## Board of Zoning and Planning

### Staff Report

March 28, 2024

##### **1) Application Number: BZAP-24-4**

**Update since the ARB meeting:**

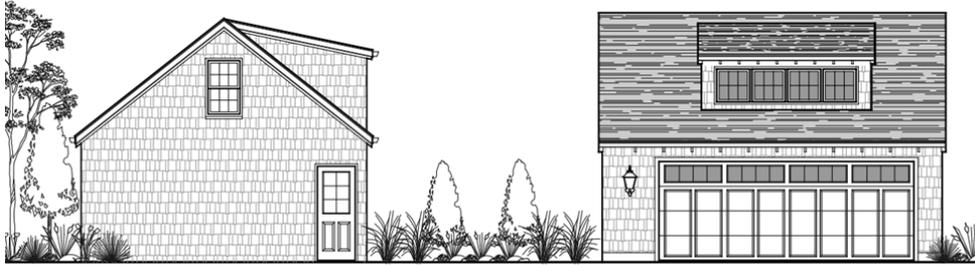
The applicant has submitted updated plans. The existing and new garages are different in size, but the recent changes now make the two structures similar in design.

The changes triggered a few variances from Bexley Code Section [1252.15](#), in the effort to better mirror the existing garage. The following items would be variances: dormer size, attachment to ridge and 2<sup>nd</sup> floor square foot limit of 50%.

The applicant has also proposed an arbor structure, which is not necessarily lot coverage, but may or may not contribute to the 60% of the lot width limit for detached garages and was also a design suggestion from the ARB members.

Date: 12 Mar 2024  
Drawing Title: S. Garage Elevations  
Scale: 3/16" = 1'-0"  
Project Number: 23-099  
Project Name: The Barger Residence  
Sheet Number: 1 of 1

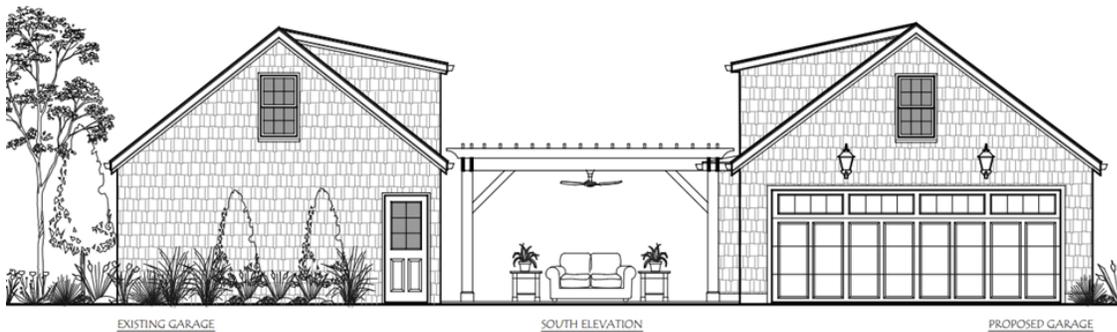
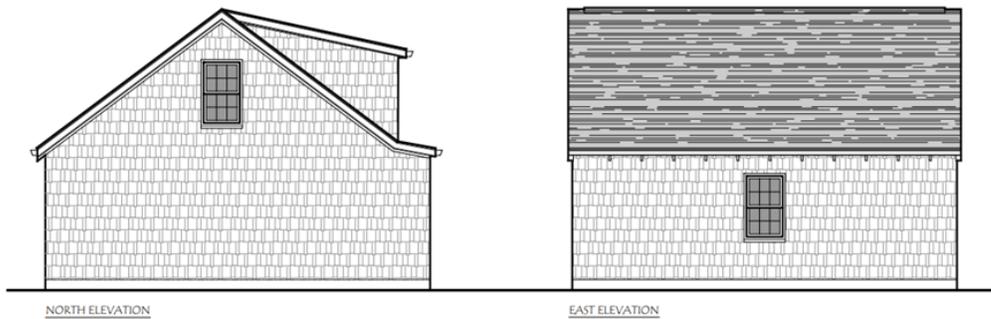
**Plan A - (Original Design)**

If the Board finds it appropriate to approve the original garage, it requires a Special Permit in accordance with Bexley Code Section **1252.15(a)** to allow a functional dormer

**Plan B - (Modified Design)**

The applicant decided to also provide update a plan that will match the existing detached garage. If the Board finds it appropriate to approve the redesigned plan for the garage it needs to consider the following:

The new garage structure requires variances to **1252.15(d)** , as it has a larger dormer which exceeds the size limits and placement on the roof, Bexley code Section **1252.15(a)** to allow the second floor space to exceeds the 50% limit of the 1<sup>st</sup> floor space by 2.7%, and a Special Permit to allow for a functional dormer, 1252.15 (d)(1) to allow the dormer eave length to exceeds 50%(, **1252.15(d)(3)**, to allow the dormer to be at the ridge and **1252.15(b)(2)** If the arbor is approved as part of the redesigned plan.

**2) Application Number: BZAP-24-6****Address: 2529 E. Broad****Applicant: Amy Lauerhass****Owner: Marcel Bischoff and Melissa Salguero Rottier**

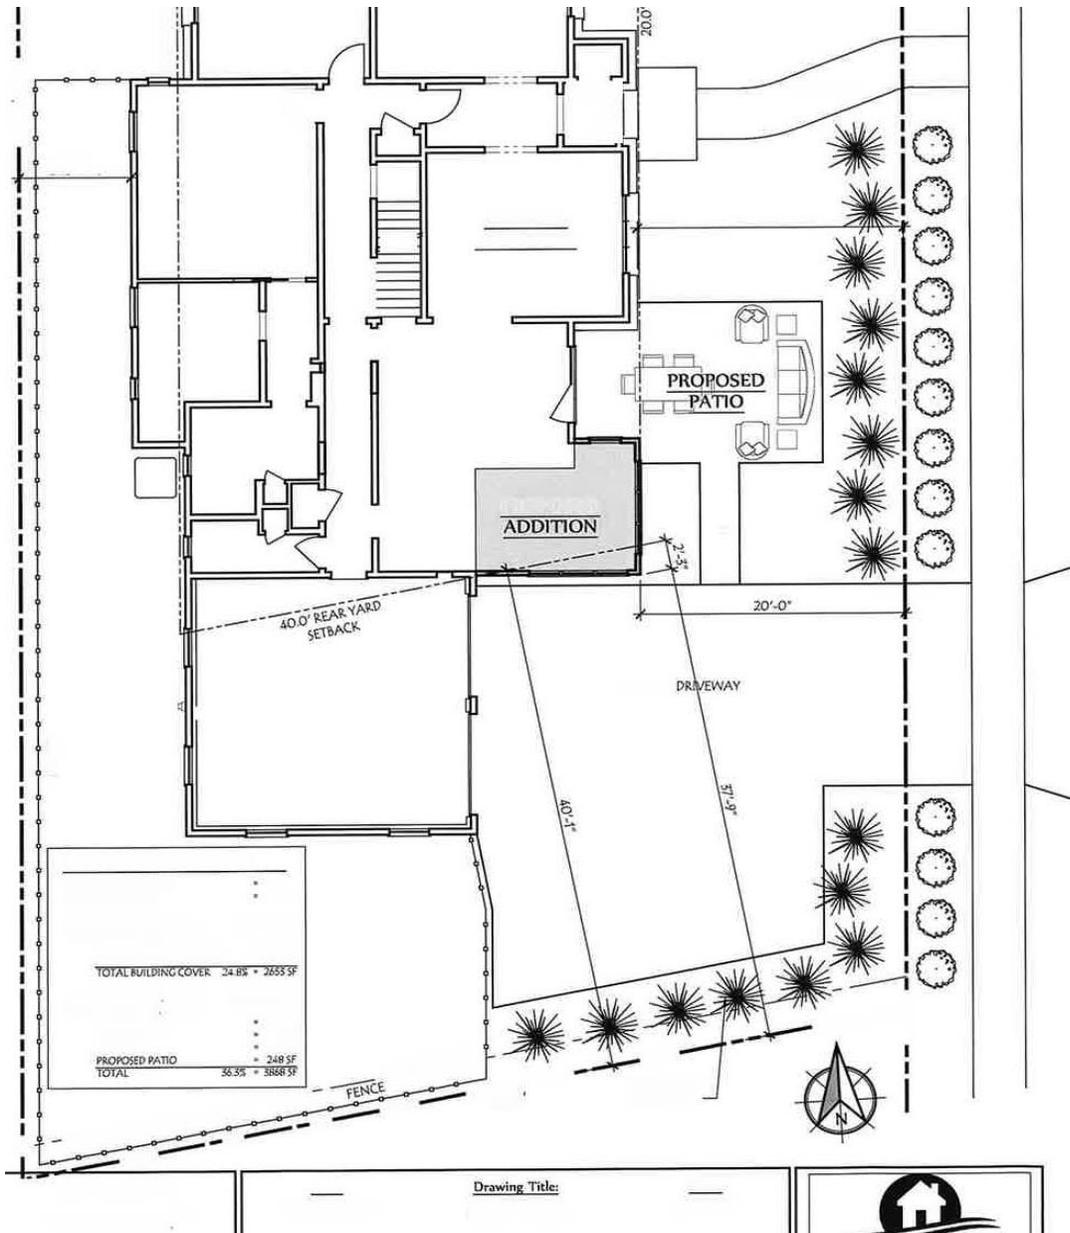
The existing structure meets the required 20' side yard setback along N. Cassady. The attached garage is considered part of the principal structure and it encroaches 20' into the required 40' rear yard setback.

The addition is proposed along the east side of the house (along Cassady) and will be located at the same setback from Cassady, as the existing house.

The rear property line is angled, which places a portion of the southeast corner of the proposed addition into the setback and encroaching from 1" - 2'3", along a 10' section of the south wall of the addition.

If the Board finds it appropriate to grant a variance from Bexley code Section 1252.09 (R-3 Zoning District), the attached garage portion of the existing principal structure encroaches 20' into the rear yard setback, while the addition on the east side of the house will be 37' 9 " from the south (rear) property line. (which is a 2'3" encroachment)

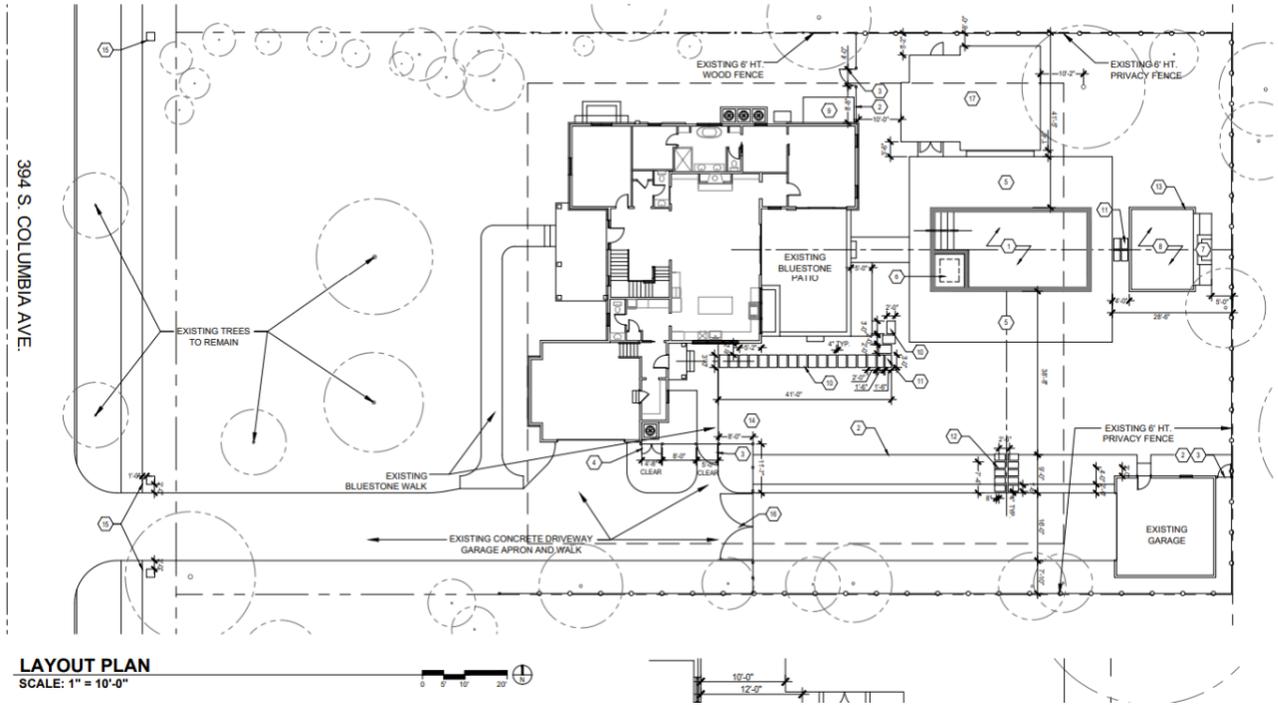
Request: The applicant is seeking a Special Permit in accordance with Bexley code Section 1264.02(c) which limits front yard fences and walls 24" – 42", to allow three 36" high columns at the driveway entrance and at the northwest corner of the property and within the City right-of-way.

The fact that the columns are proposed in the City right-of-way, further requires approval of City Council and a Hold Harmless Agreement.

**C STONE ENTRY COLUMNS**  
SCALE: 1/2" = 1'-0"

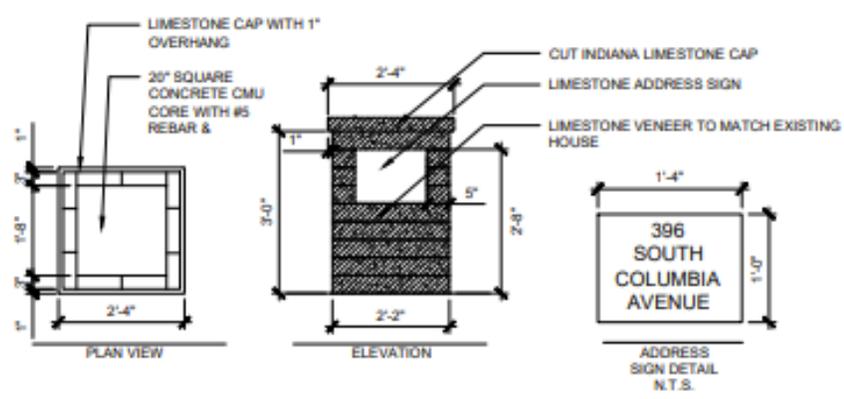
The proposed columns are 3' high with a 4" limestone cap. The columns are 2'4" wide.

The owners have indicated that because of the existing Oak tree, they would like to construct these with a 1.0' offset from the east edge of the existing sidewalk which would permit construction of the columns without impact to the existing Oak tree root structure.

The Board should discuss both the placement and style of the proposed columns. There would be landscaping proposed around the columns. If the Board finds it appropriate to grant a Special Permit, it should be subject to the landscape review and approved by the Bexley Tree & Public Garden Commission and approval from city Council of a Hold Harmless due to the location in the right-of-way.
